ASSESSMENT REPORT – Mixed Use Development S79C – Environmental Planning & Assessment Act 1979

DA No:	DA/315/2013
Assessment Officer:	Stan Fitzroy-Mendis
Property:	2-8 East Street, Granville Lot 1 DP 712486 (2 East Street), Lot 2 840483 (4 East Street), Lot 1 DP 798201(6 East Street), Lot 4 DP 559058 (8 East Street)
Proposal:	Demolition, tree removal and construction of a 19 storey mixed use development comprising a commercial use on the ground floor and 208 apartments over a basement.
Capital Investment Value:	\$42,526,648
Date of receipt:	30-May-2013
Applicant:	Robert Del Pizzo
Owner:	Mr Adnan Dandan & Mrs Laila Dandan
Submissions received:	No submissions received
Property owned by a Council employee or Councillor:	The site is not known to be owned by a Council employee or Councillor
Issues:	Height, Stormwater Management
Recommendation:	Approval

Figure 3: North elevation of the proposal in a figure ground diagram.

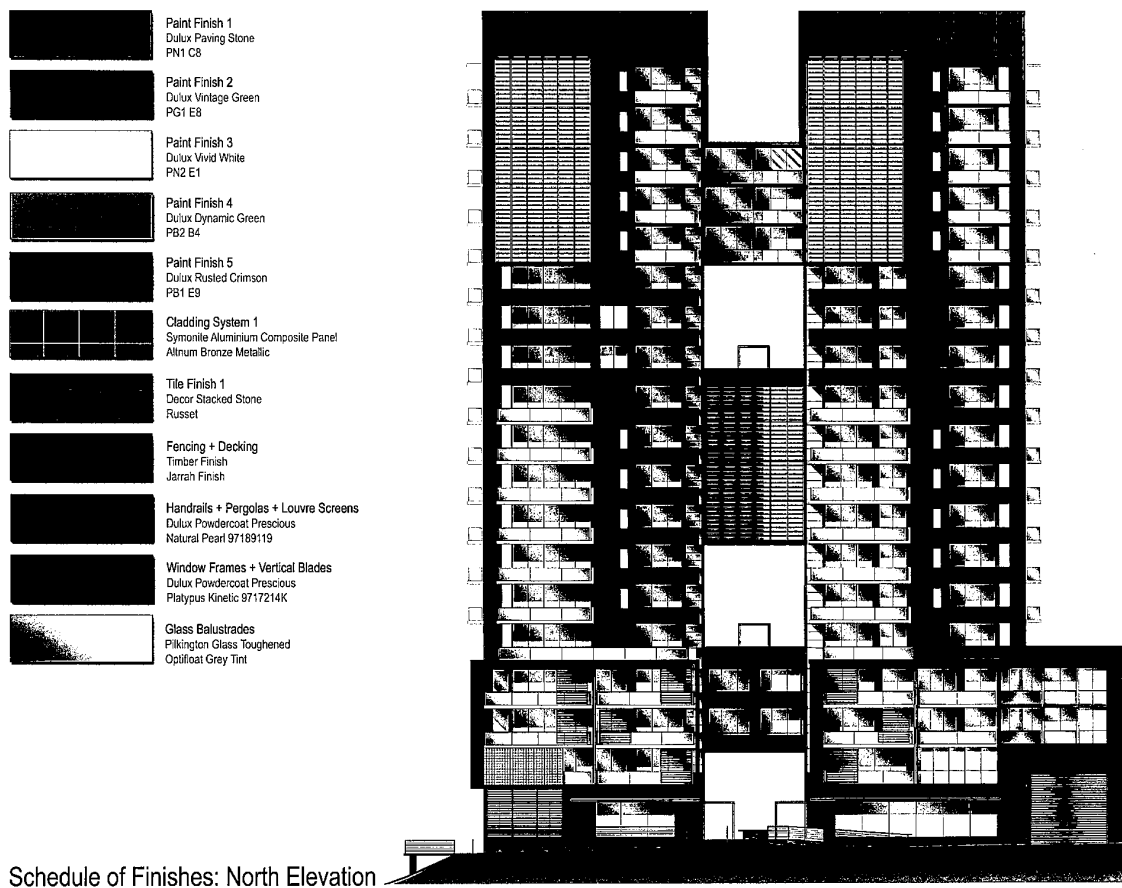
DEAP assessment considered the proposal at pre-DA stage within the context of the site being within an urban renewal precinct. The building as originally submitted was considered by the DEAP to be excessively bulky. The DEAP suggested way to mitigate this bulk as follows:

- Reduce the floor plate of each tower;
- Make the connecting elements between the towers recessive so that the towers present as two elements rather than one bulky mass;
- Chamfer the edges of the building to reduce bulk; and
- Increase the height with that height incorporating recessive elements.
- The additional height in conjunction with the other design changes was to in concert mitigate the impacts of bulk and scale.
